PROJECT : HONOAPIILANI HIGHWAY
Kahana to Alaeloa

PROJECT NO.: F-030-1(13)

DRAINAGE

STATE OF HAWAII
DEPARTMENT OF TRANSPORTATION
LAND TRANSPORTATION FACILITIES DIVISION
DRAINAGE & IRRIGATION PLAN
HONOAPIILANI HIGHWAY
Kahana to Aiealoa
F.A. Proj. No. F-030-1(13)

Scale: As Shown Date: Sept, 1977
SHEET NO. 41 OF 8 SHEETS

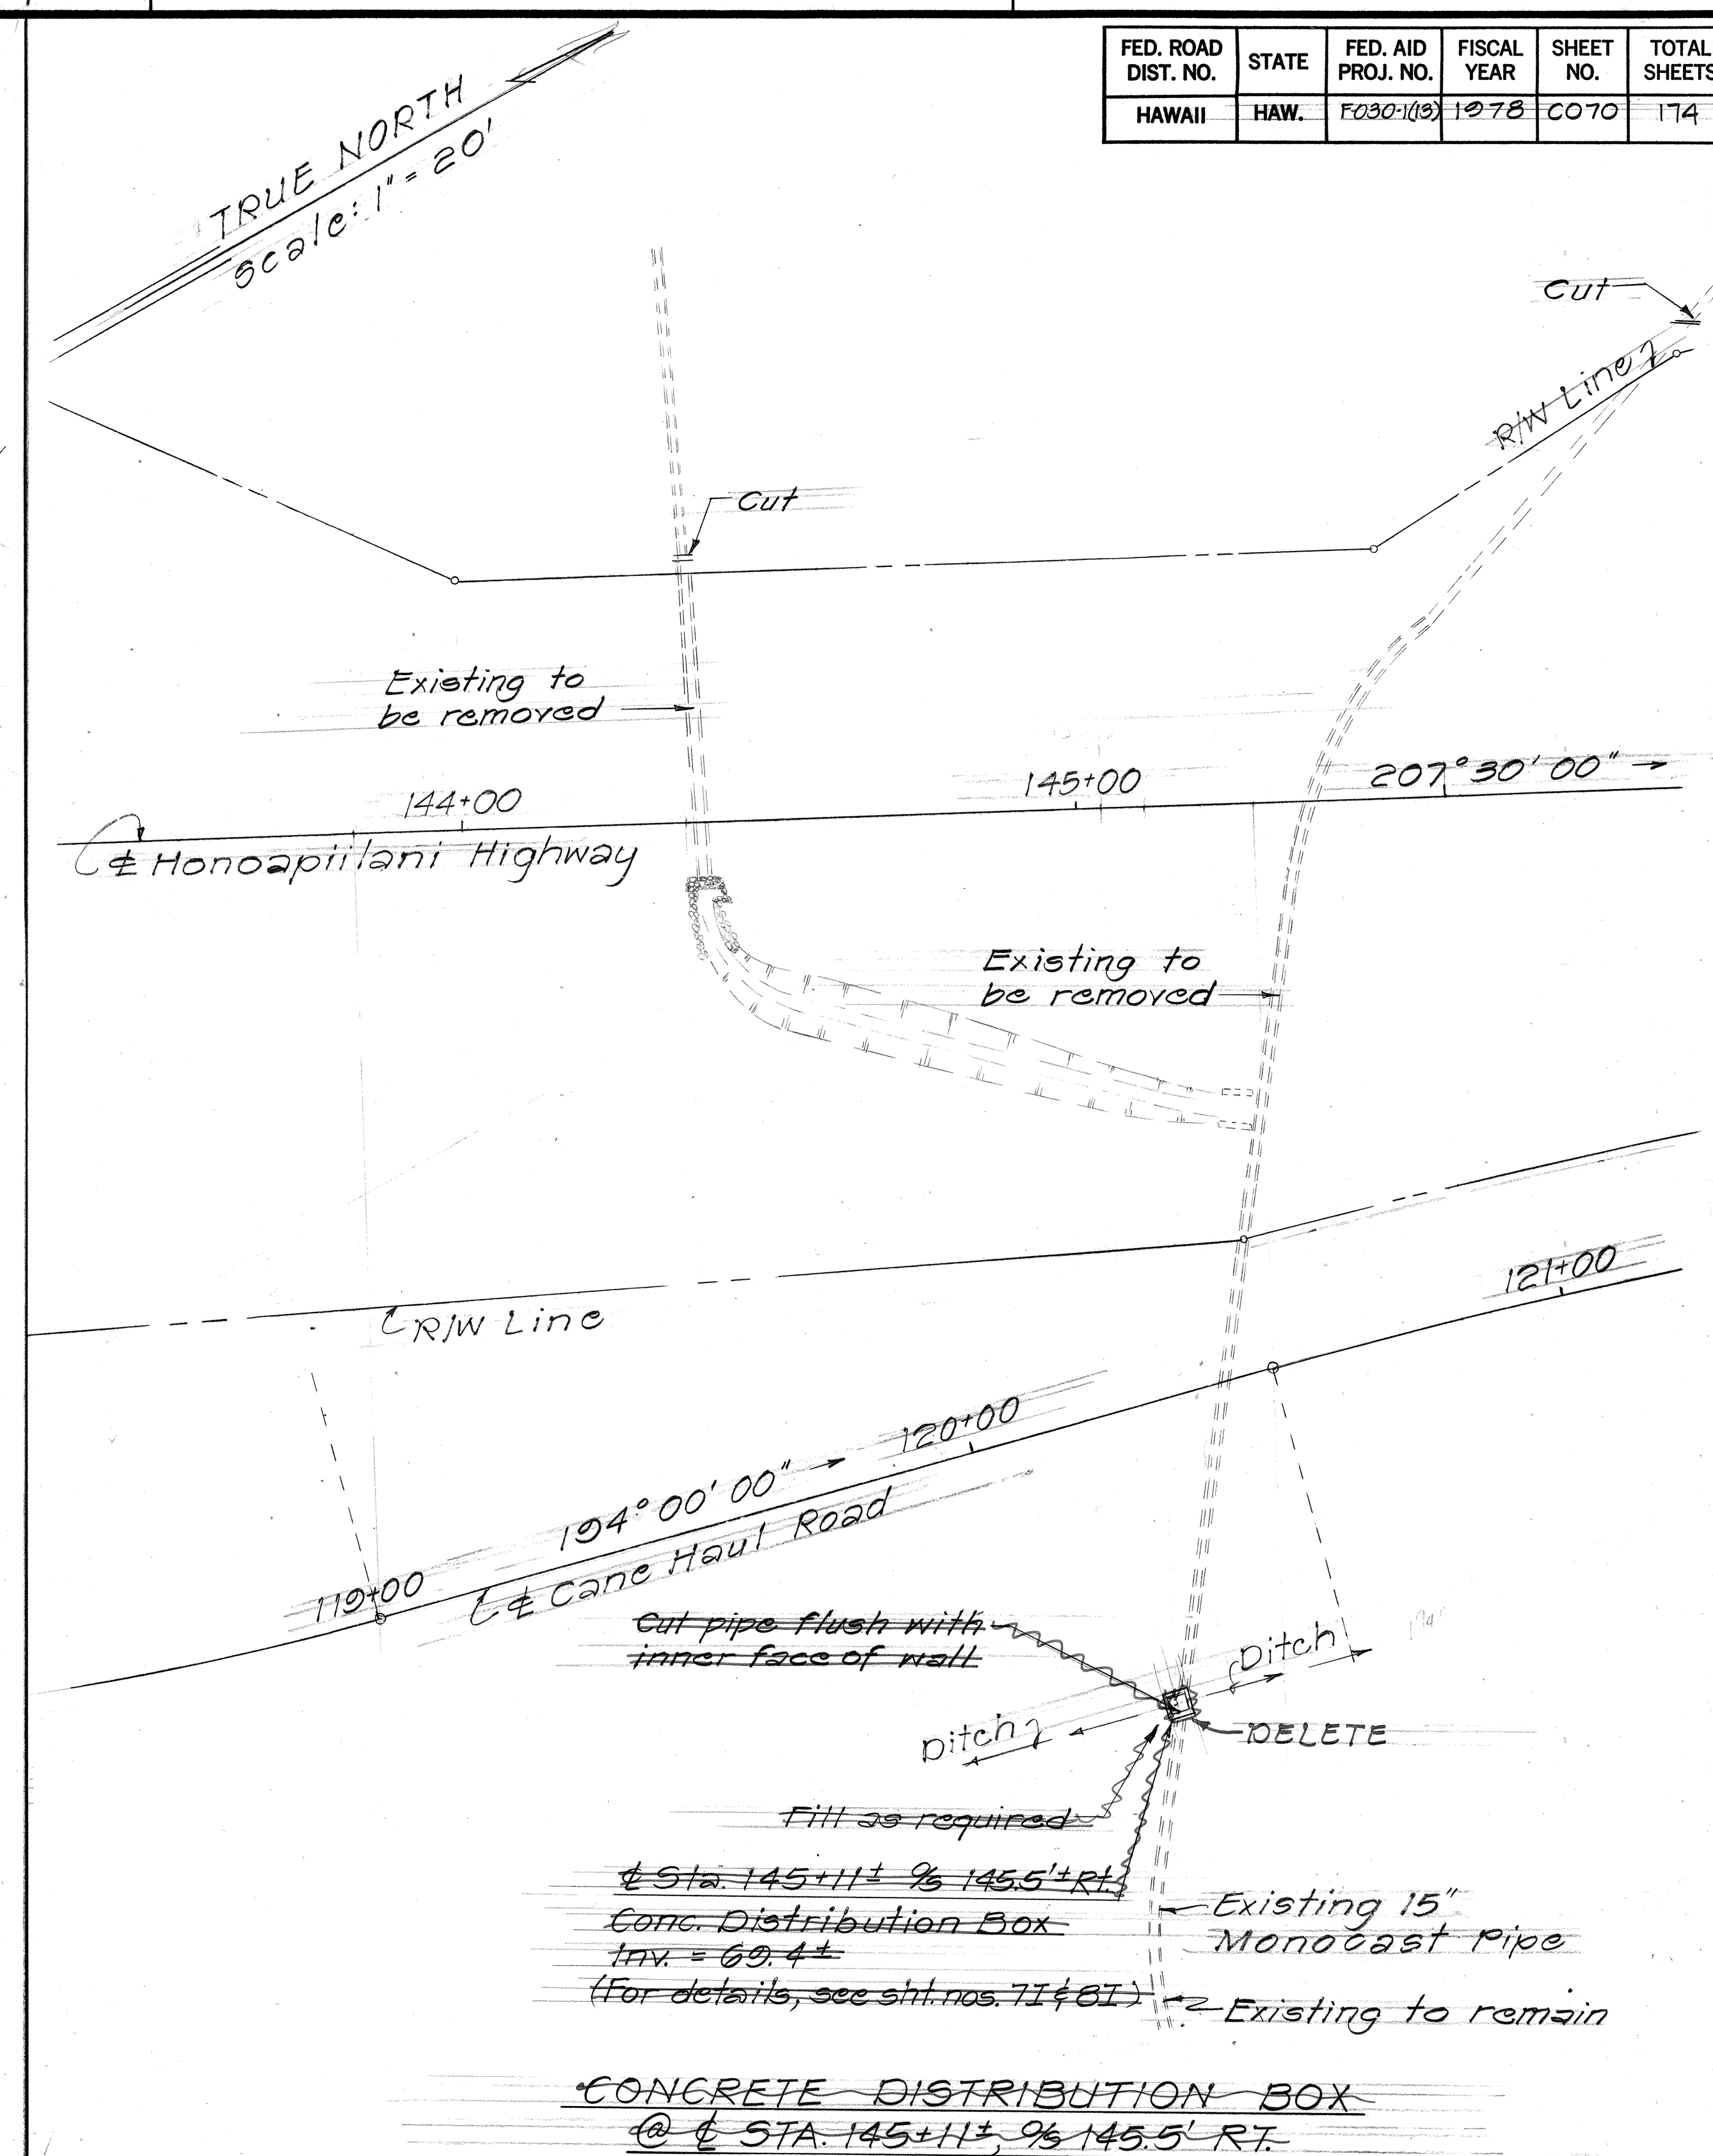
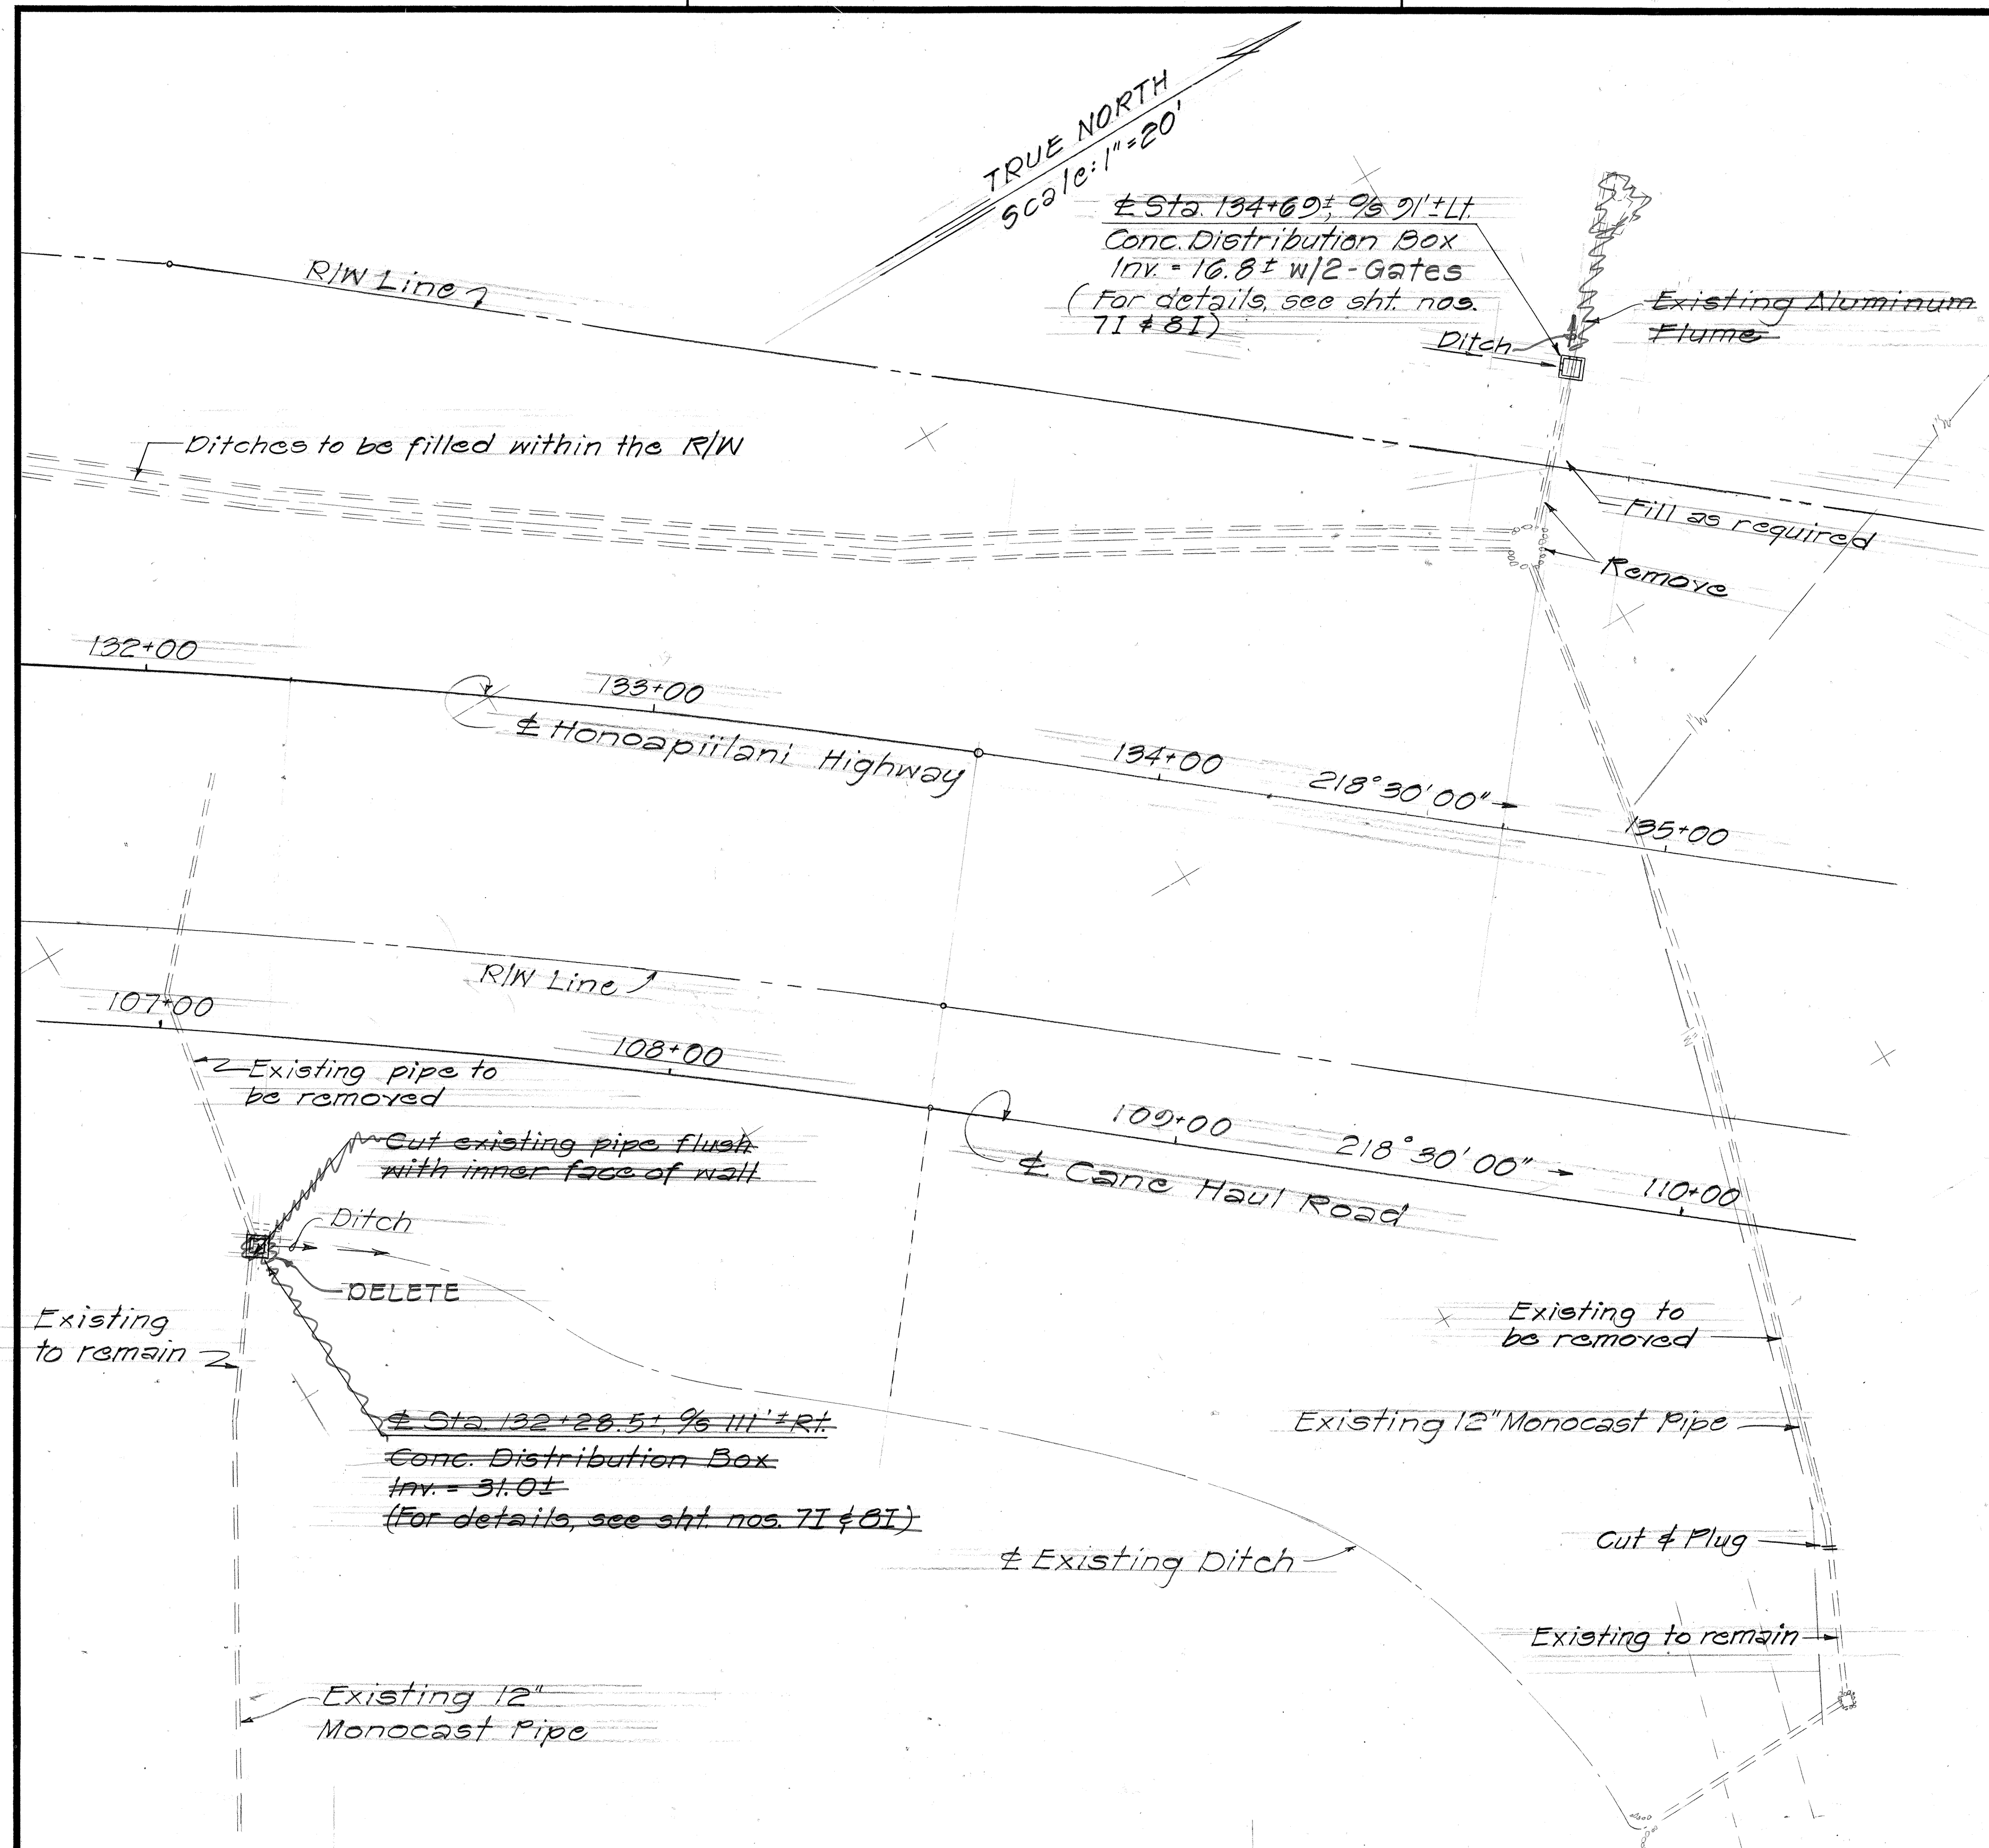
13 Nov '79 Delete 3" PVC pipe between Sta 144+00 Lt & 145+60 Lt. Delete 4" PVC pipe at Sta. 145+60.
